Vermont Yankee Nuclear Power Station
Proposed Technical Specification Change No. 263 – Supplement No. 23
Extended Power Uprate
Response to Request for Additional Information
Exhibits

Vermont Yankee Nuclear Power Station
Proposed Technical Specification Change No. 263 – Supplement No. 23
Extended Power Uprate
Response to Request for Additional Information
Suppression Pool Cooling Study

VYNPS Suppression Pool Cooling Study Performed With 2 RHR Pumps

REPORT No. VY-RPT-05-00003

Figure 3-2

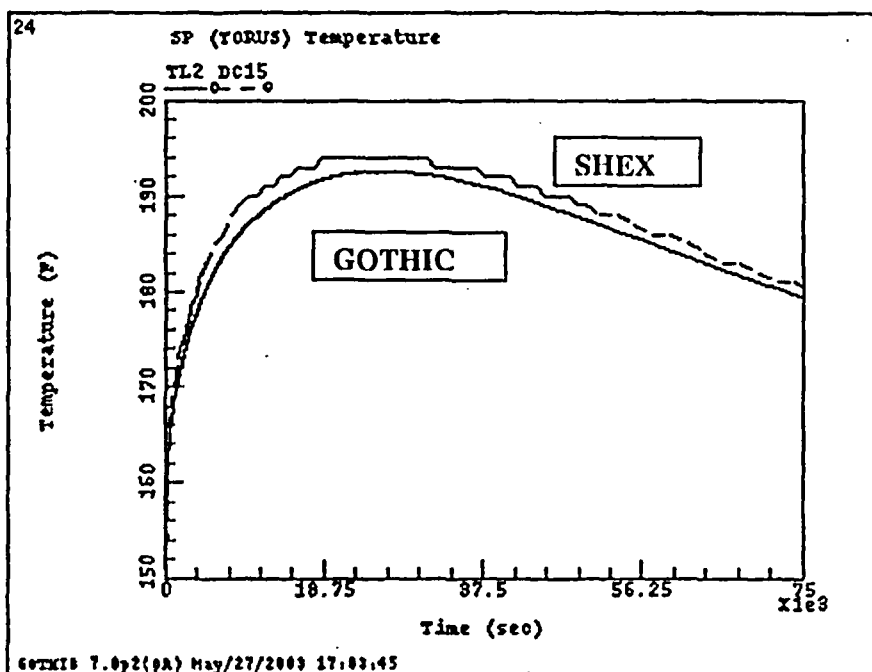
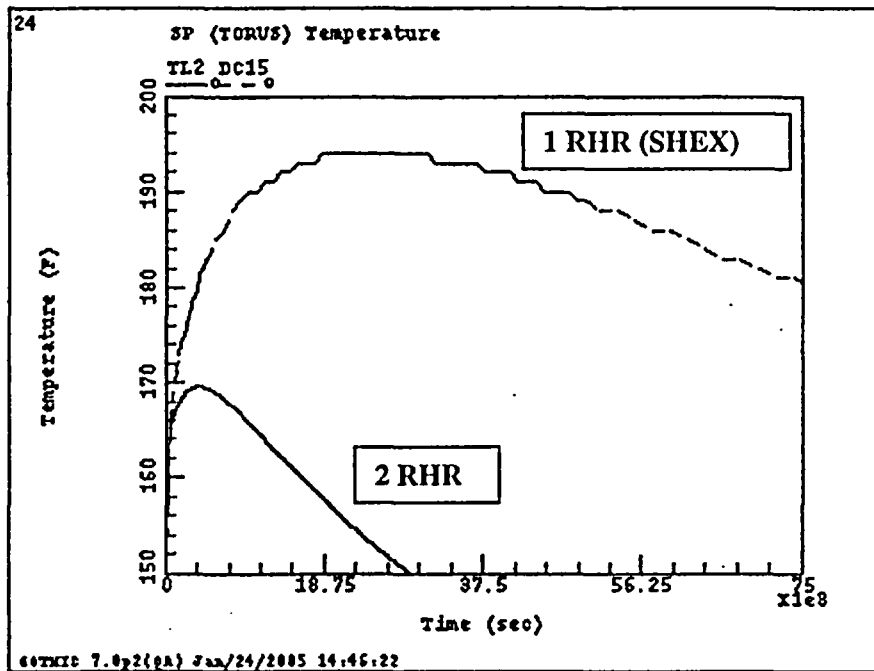
Comment Number	Section/ Page No.	Review Comment	Response/Resolution	Responsible Engineer's Accept Initials
1	Various	Minor editorial changes.	Completed	CSB
2	References	Please add RHR DBD as a reference.	Completed	CSB
3	Section 3.2	Indicate/label data curves for graphs.	Completed	CSB
Reviewed/ Verified By:		 Pedro B. Pérez	Date:	2-10-05
Site/Department:		VYNPS/Design Engineering, Fluid Systems	Phone: 802-451-3118
